Planning Commission Minutes  
March 13, 2025

18. (SPUD-1717) Application by Sam Gresham and Lynette Adams to rezone 2207 North Gatewood Avenue from R-1 Single-Family Residential and UC Urban Conservation Overlay Districts to SPUD-1717 Simplified Planned Unit Development and UC Urban Conservation Overlay Districts. Ward 6.

**STAFF REPORT**  
**The City of Oklahoma City**  
**Planning Commission**  
**March 13, 2025**

**(SPUD-1717) Application by Sam Gresham and Lynette Adams to rezone 2207 North Gatewood Avenue from R-1 Single-Family Residential and UC Urban Conservation Overlay Districts to SPUD-1717 Simplified Planned Unit Development and UC Urban Conservation Overlay Districts. Ward 6.**

1 SITE PLAN  
SCALE: 1/8"=1'-0"

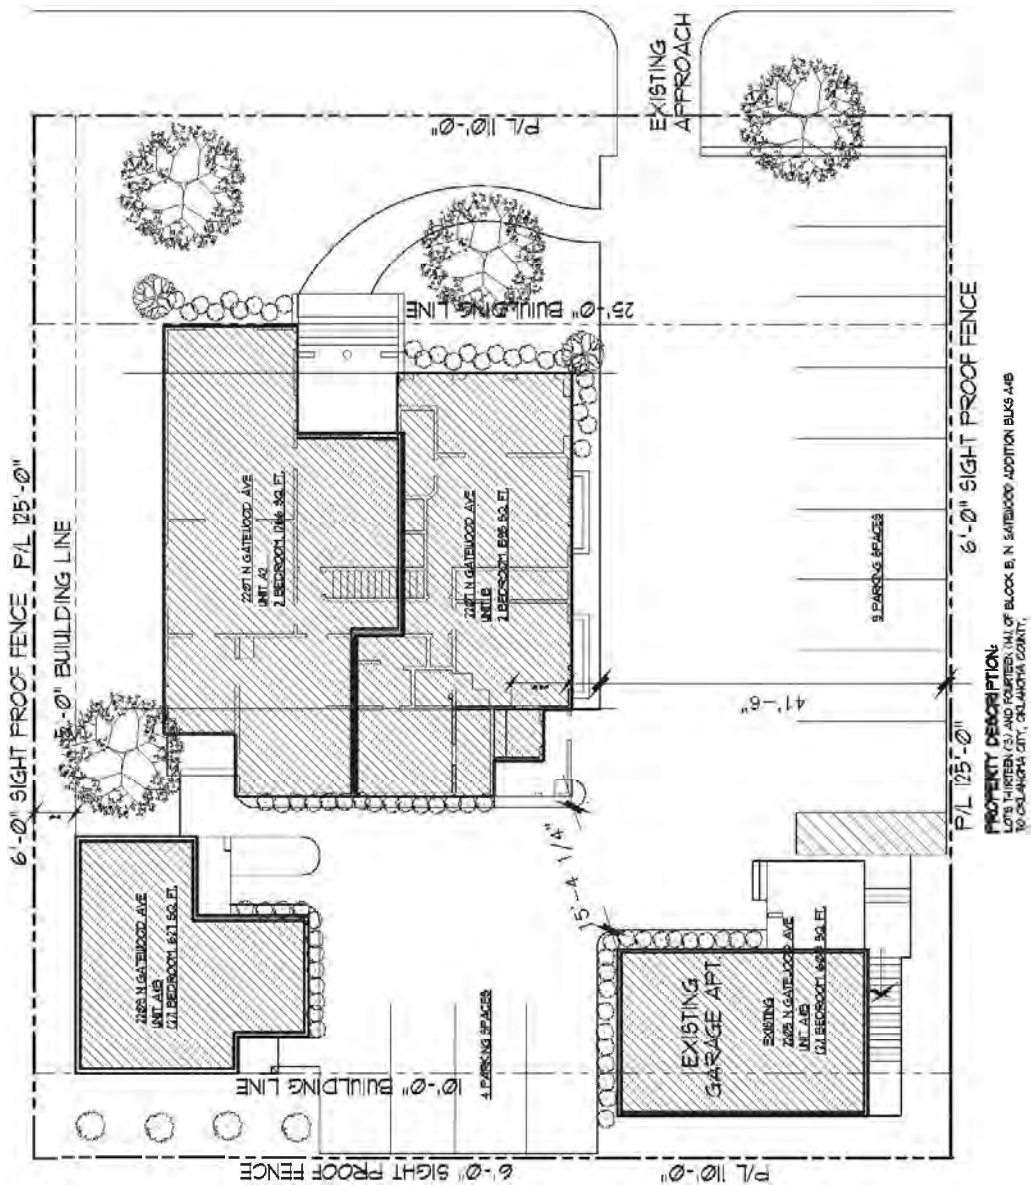
*The subject site is located along the west side of North Gatewood Avenue. The SPUD proposes utilizing North Gatewood Avenue for access. The conceptual plan for the development illustrates the site will use the existing drive along North Gatewood Avenue, near the southeast corner of the site.*

- Parking in all residential districts except R-1, R-1ZL and R-2 Districts, shall be located in the rear yard. *(The conceptual plan indicates parking located within the front and side yard setbacks.)*

- In all residential zoning districts, the maximum width of driveways is 12 feet for one-way and 20-feet for two-way drives. Circle drives are permitted, but unconnected drives in the front are not. *(The existing driveway satisfies this, but the SPUD does not address. Conceptual plans indicate 41 feet of paving for new parking areas in the front yard).*

The proposal to increase density in the Urban Medium LUTA is in conformance with UM density ranges and comprehensive plan goals to provide a mixture of residential housing types and infill development. However, the increased parking and placement in the front yard is not consistent with the Gatewood UCD. Parking areas should be located behind the front wall. Additionally, the Master Design Statement should address retention of the existing home.

1. The Master Design Statement shall specify that the existing home is being retained.
2. Parking is not permitted within the front yard setback except on a driveway meeting the width requirements of the Gatewood UC District.

1. The Master Design Statement shall specify that the existing home is being retained and may be converted to a duplex.
2. ~~Parking is not permitted within the front yard setback except on a driveway meeting the width requirements of the Gatewood UC District.~~ A maximum 4-foot-tall sight proof stone, masonry, or stucco wall shall be provided to screen any parking past the front yard setback.
3. The maximum building height shall be 2 stories and 30 feet.
4. No rooftop decks shall be allowed, and any second story balcony shall face the interior or front property line.
